ADDENDUM

Project Name: Field House – Press Box & Toilets Addendum No.: **One (1)**
 Canadian ISD Date: January 20, 2009
 Canadian, TX Project No.: 07008.9

YEAR 2008 IMPROVEMENTS
FIELD HOUSE - PRESS BOX & TOILETS
 FOR THE
CANADIAN INDEPENDENT SCHOOL DISTRICT
 CANADIAN TEXAS

SHEET NO.
SD1
 OF 24

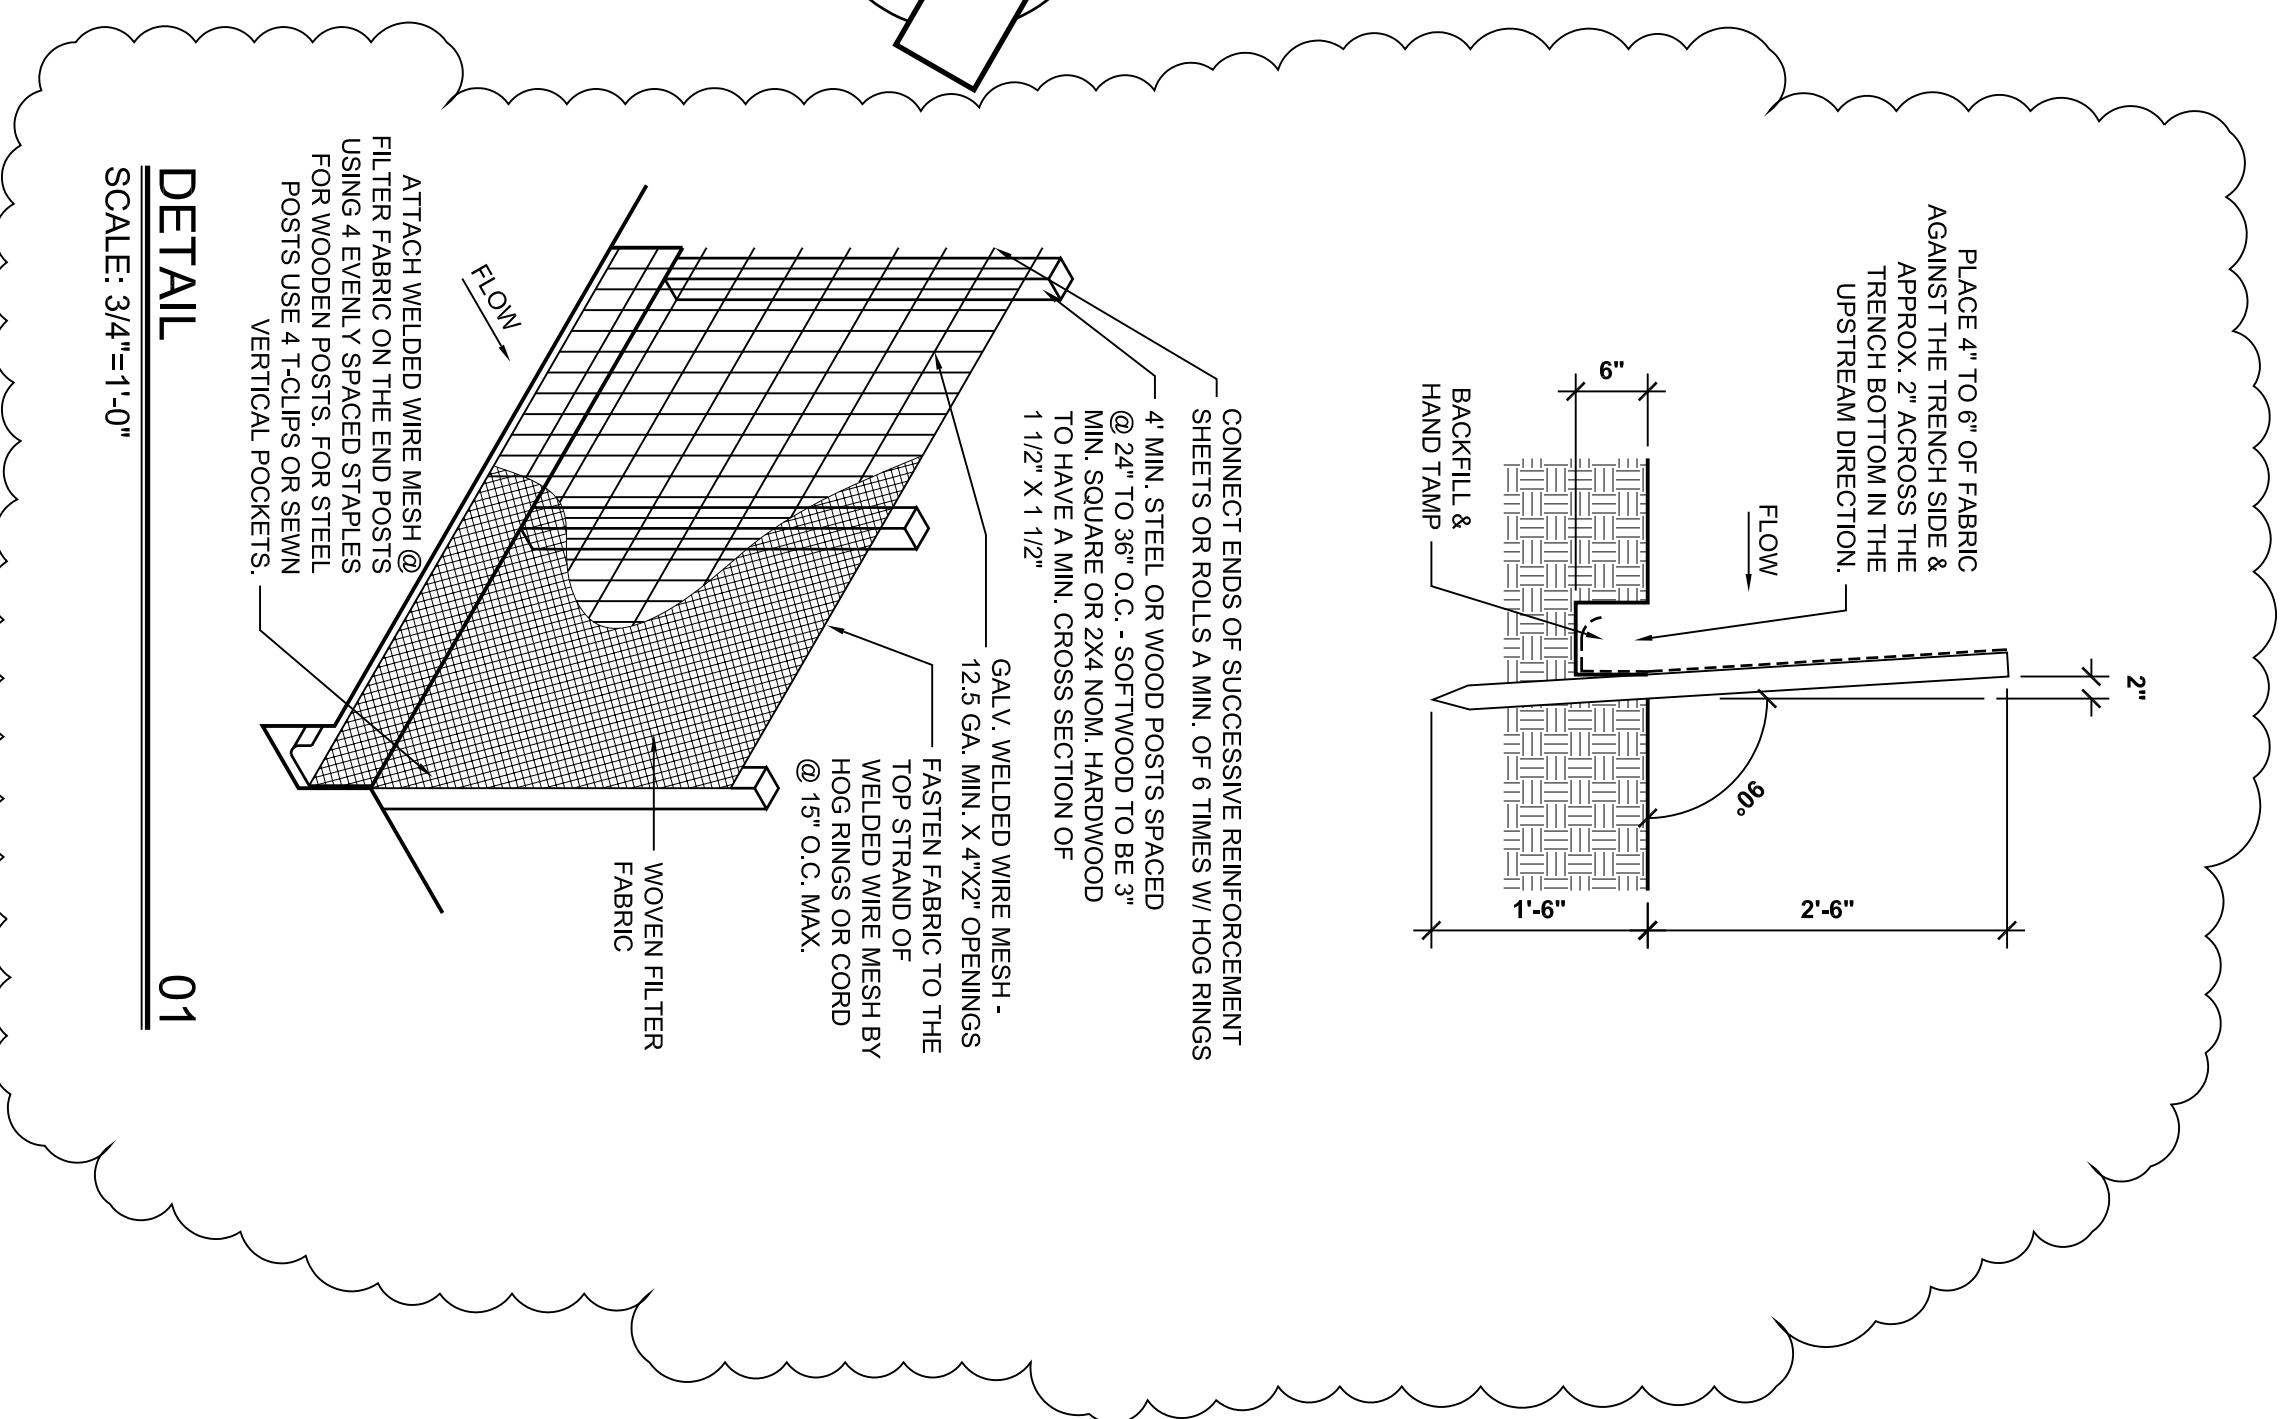
- Item No. Two:** In the Drawings, Sheet C2 SWPPP – For clarification purposes replace Sheet C2 with Supplemental Drawing SD-1 attached herewith.
- Item No. Three:** In the Drawings, Sheet A1 Floor Plans & Door Schedule – Field House Floor Plan, For clarification purposes, all walls of the showers are to be finished with ceramic tile in lieu of FRP panel.
